Undetected FDF Failure

Henry May
4/08/2013

IBM Late Letter Ballot Comment

FDF Joins the Fabric and then Restarts

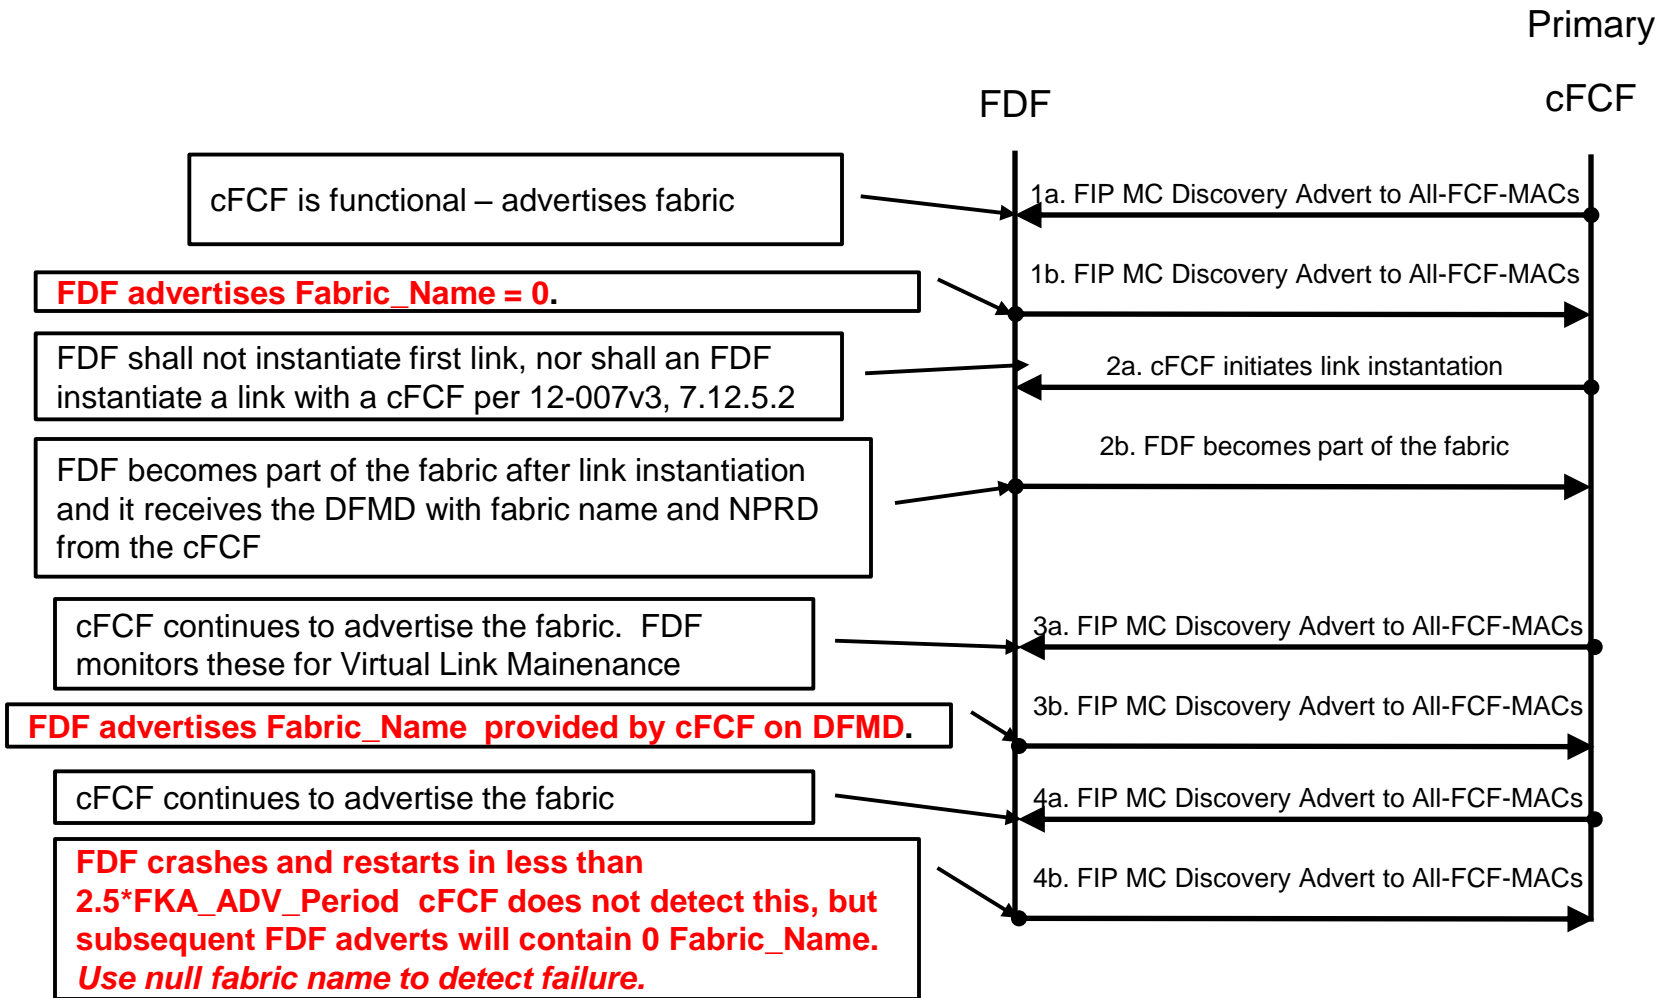
- **12-007v3, Section 7.12.5.3**
VA_Port to VA_Port Virtual Link maintenance is performed as for VE_Port to VE_Port Virtual Links.
- **12-007v3, Section 7.9.5.3**
If unsolicited multicast Discovery Advertisements are not received within $2.5 * FKA_ADV_PERIOD$, the VE_Port to VE_Port Virtual Link associated with that FCF-MAC shall be explicitly de-instantiated along with the associated VE_Port.
- **12-007v3, Section 7.12.5.2**
A VA_Port capable FDF-MAC shall not initiate a FIP ELP Exchange with a VA_Port/VE_Port capable FCF-MAC.
- **What happens if the FDF fails and restarts in less than $2.5 * FKA_ADV_Period$?**
 - **Failure is undetected by cFCF and the FDF is not allowed to instantiate a new link.**

The FCoE Controller for a VA_Port capable FCF-MAC shall monitor the status of a VA_Port to VA_Port Virtual Link by verifying the reception of unsolicited multicast Discovery Advertisements. Unsolicited multicast Discovery Advertisements are expected to be received every FKA_ADV_PERIOD. If unsolicited multicast Discovery Advertisements are not received within 2.5 * FKA_ADV_PERIOD, the VA_Port to VA_Port Virtual Link associated with that FDF-MAC shall be explicitly de-instantiated along with the associated VA_Port. That FDF-MAC shall be removed from the FCF List (see 7.9.3.3). **In addition, if, after reception of at least one Discovery Advertisement with the WWN present in the Fabric Name Descriptor, two consecutive Discovery Advertisements are received which contain zero for the WWN in the Fabric Name Descriptor, the VA_Port to VA_Port Virtual Link associated with that FDF-MAC shall be explicitly de-instantiated along with the associated VA_Port. That FDF-MAC shall be removed from the FCF List (see 7.9.3.3).**
